**NUCLEAR REACTOR LABORATORY**  
AN INTERDEPARTMENTAL CENTER OF  
MASSACHUSETTS INSTITUTE OF TECHNOLOGY

Subject: License Amendment for MIT Research Reactor, License No. R-37, Docket No. 50-20, Technical Specification No. 6.6 - "Design and Operation of the Fission Converter Facility"

Safety Review #-0-01-8 – Changes to MITR Technical Specification 6.6.3

## Model 709 Level Switch Float and Body Top-Mounted, One Switch Station

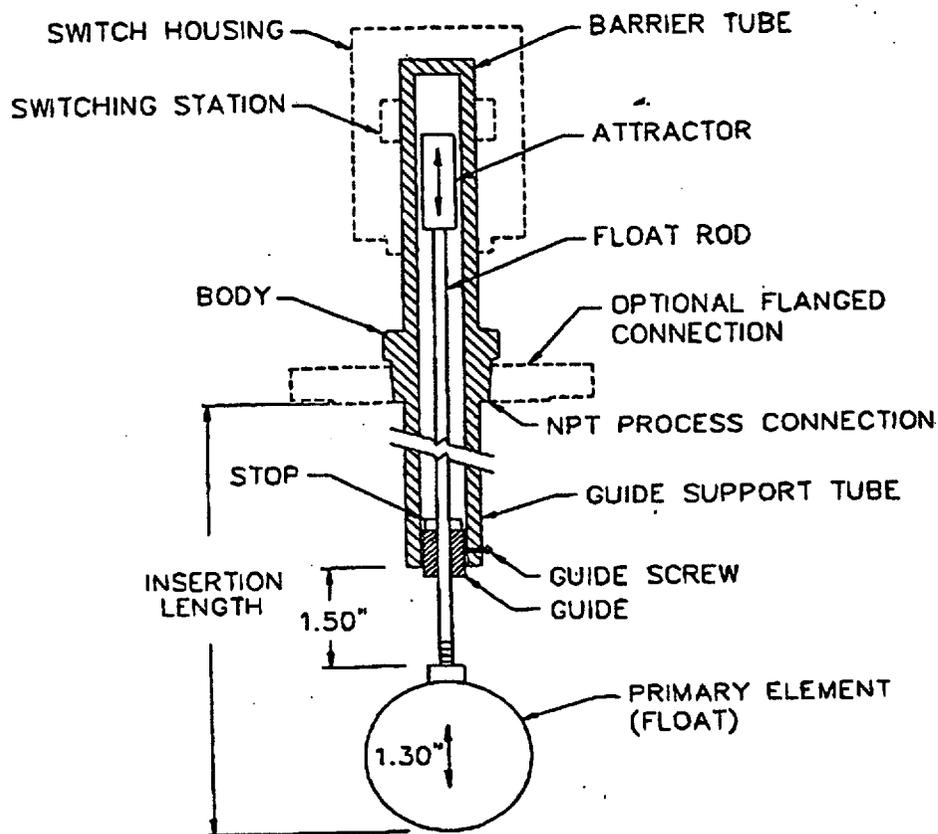
Specification 2(d) The Fission Converter (FC) tank coolant level channel provides a reactor scram and CCS closure if the FC coolant drops below 2.1 m above the top of the fuel. The level probe (a float switch, vendor's diagram attached) is set to activate at 2.2 m above the top of the fuel. This position is not adjustable. Any significant positioning changes would occur only if the switch were to become detached from its position. If this were the case, the level probe functional test as required in TS 6.6.3.1 would indicate the malfunction.

A calibration, as required in TS 6.6.3.2, is very difficult in that the FC top shielding and lid cover must be removed, D<sub>2</sub>O slowly removed from the FC tank, and the level measured. This requires significant manpower and personnel dose to measure an activation level which cannot change. It is therefore proposed to eliminate TS 6.6.3.2(d). It should be noted that TS 6.6.3.1 remains unchanged and it requires, among other things, an operability check of the FC tank coolant level channel. Hence, the proposed elimination of TS 6.6.3.2(d) does not decrease safety. Operability of the level channel is still assured via testing. The only change is to eliminate a calibration requirement that is both difficult to perform and wasteful of D<sub>2</sub>O, and which provides no benefit because the probe's position isn't subject to gradual change. The only possible failures in design are abrupt and those are detected by the functional test.

- a. Neutron flux level channel,
  - b. Primary coolant flow channel, *and*
  - c. Primary coolant outlet temperature channel, ~~and~~
  - ~~d. Fission converter tank coolant level channel.~~

### Calculated pH - Conductivity Relationship for Water + "Typical" Acid or Base

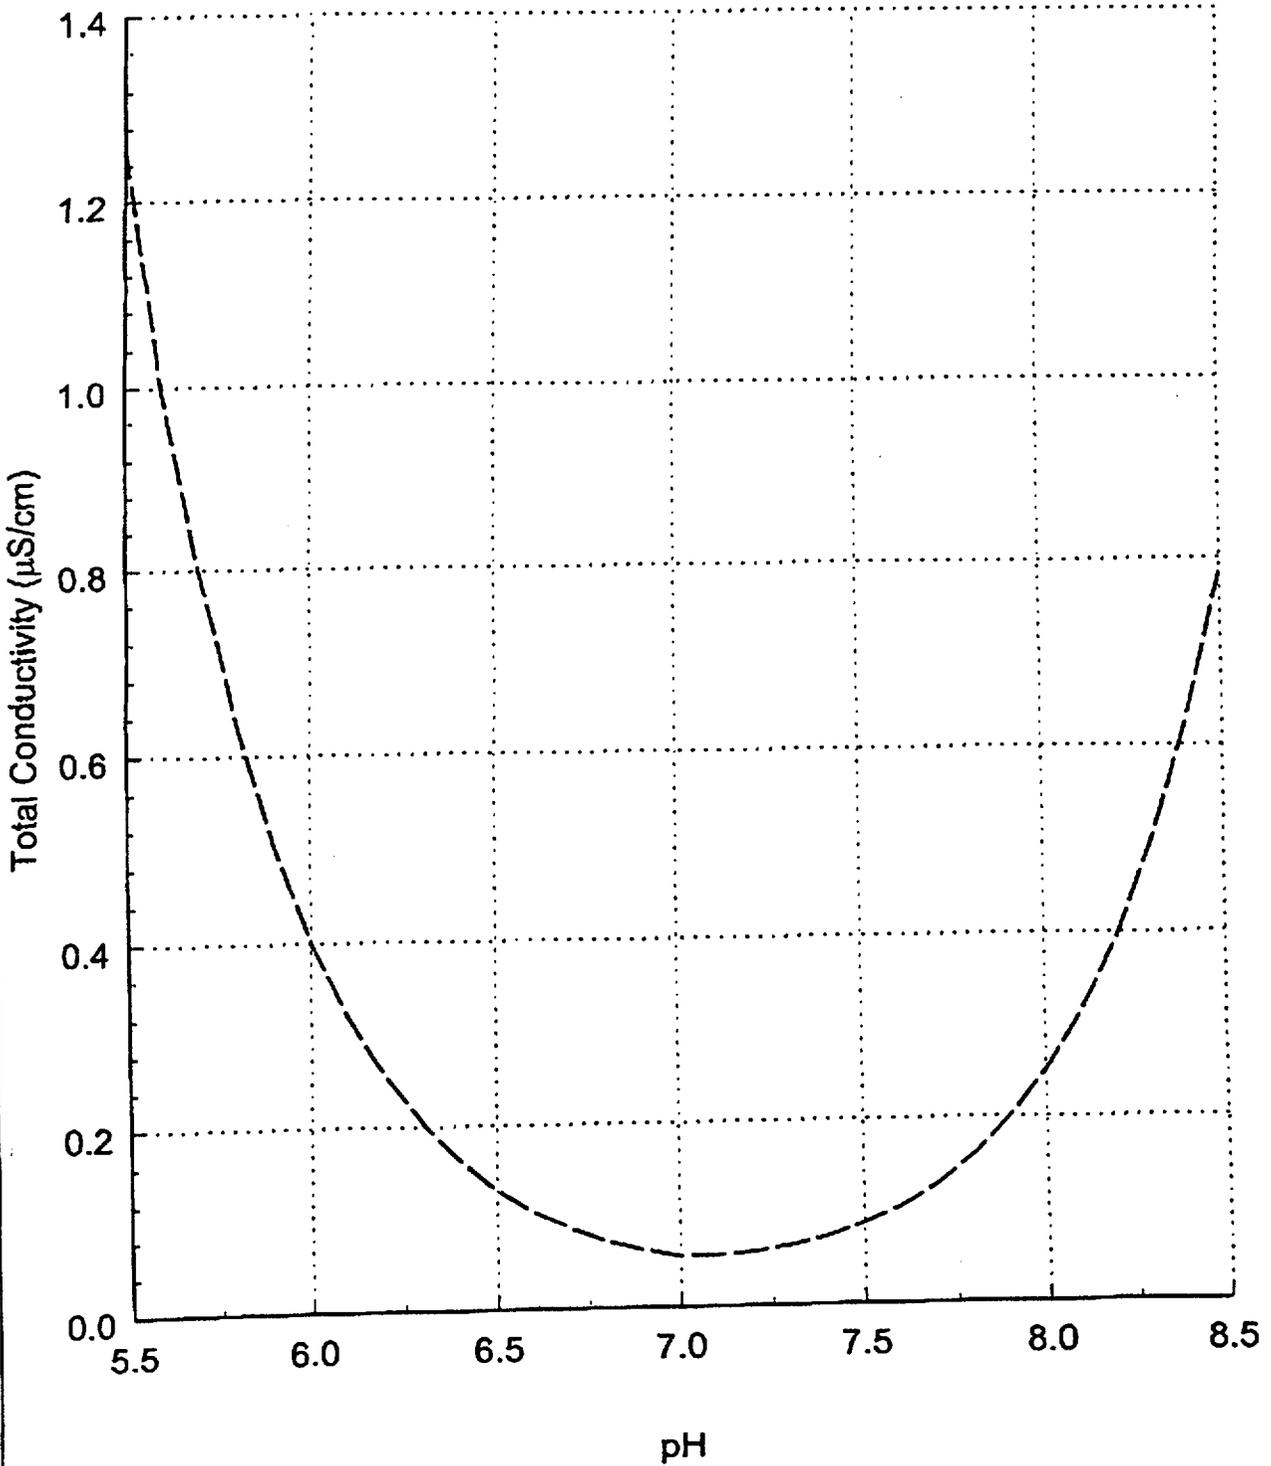
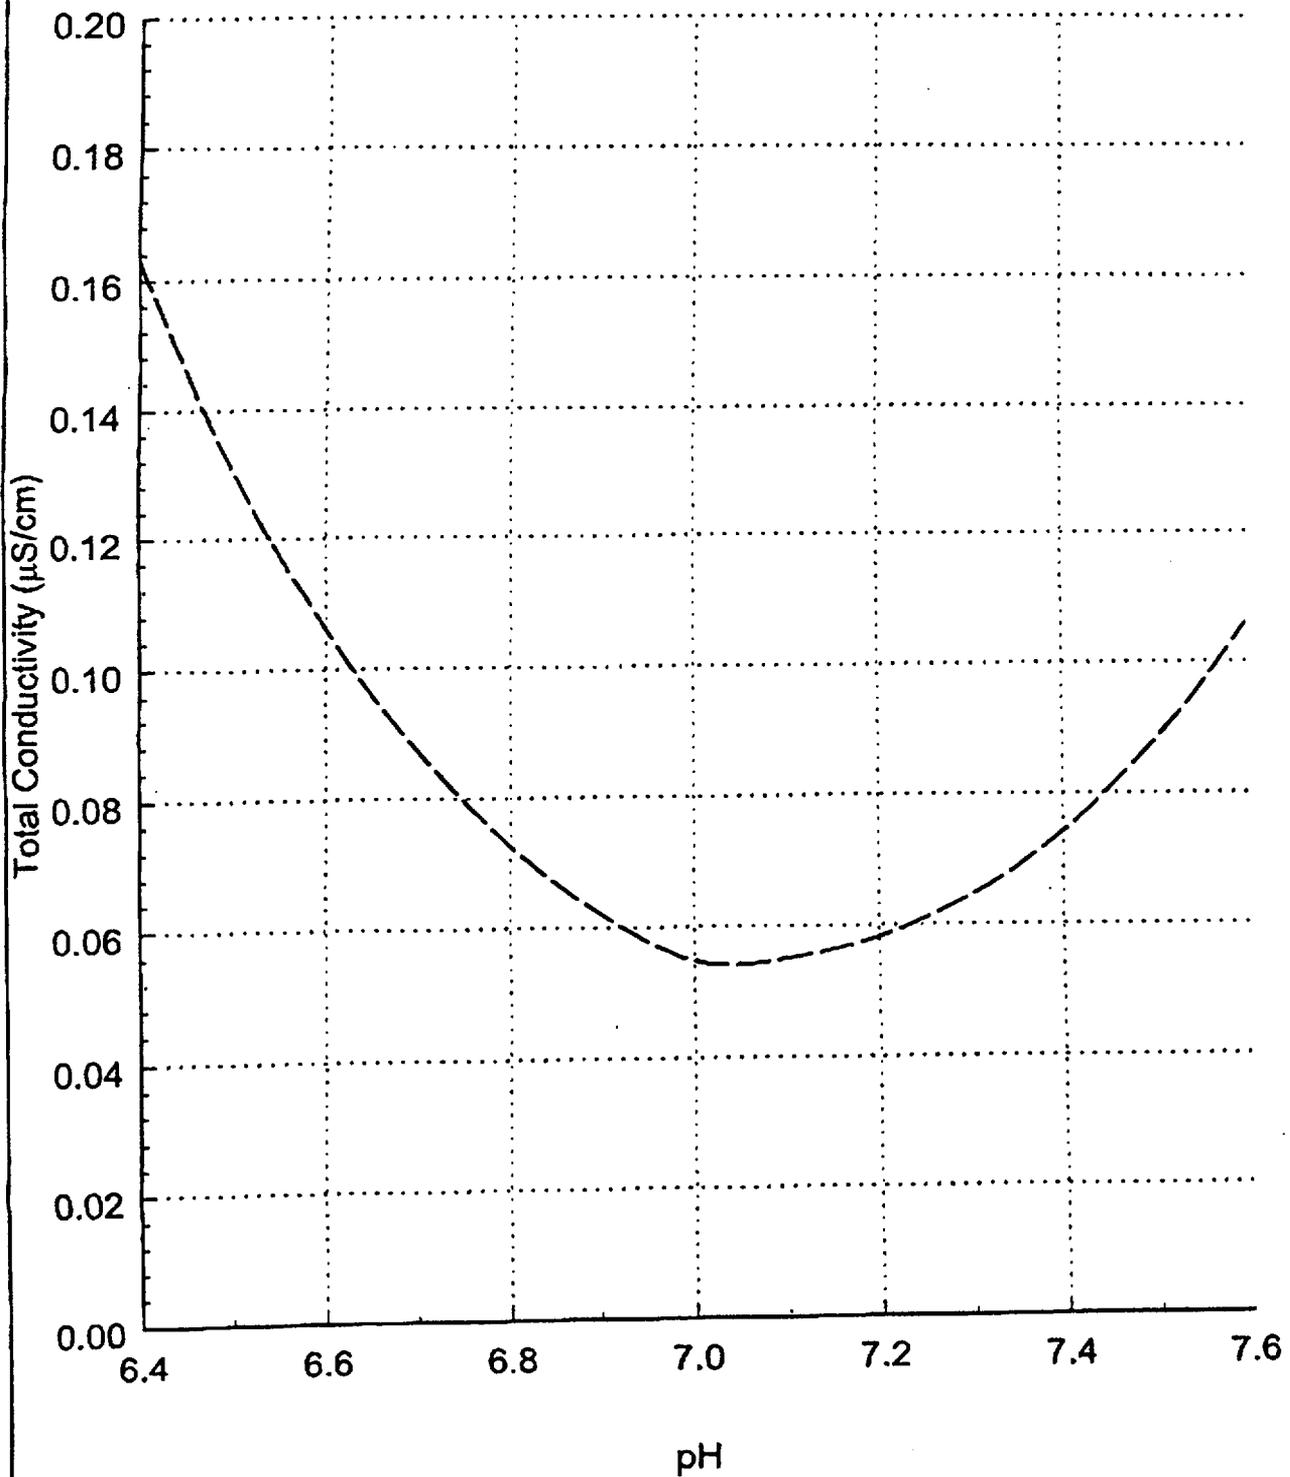
The attached figures plot the conductivity – pH relationship obtained by this procedure, first for the pH range 5.5 – 8.5 and then an expansion of the region from pH 6.4-7.6. To use the figures to establish a probable pH range for any given conductivity, simply draw a horizontal line at the conductivity value and note the x-intercepts of this line on the curve. If ionic species are present which do not affect the pH, the actual pH range would be represented by a lower conductivity value and hence would be closer to neutral. For example, if the conductivity is measured to be  $0.06 \mu S/cm$ , the pH must lie between about 6.9 and 7.2. It is therefore unnecessary to do a batch pH measurement to confirm that pH is within the allowable limits, particularly if no change in conductivity has been observed since the most recent pH measurement.

*The pH of the fission converter primary coolant shall be measured monthly if the average conductivity exceeds 0.10  $\mu\text{S}/\text{cm}$ . The tritium content of the coolant shall be determined quarterly if  $\text{D}_2\text{O}$  is used as the fission converter primary coolant.*
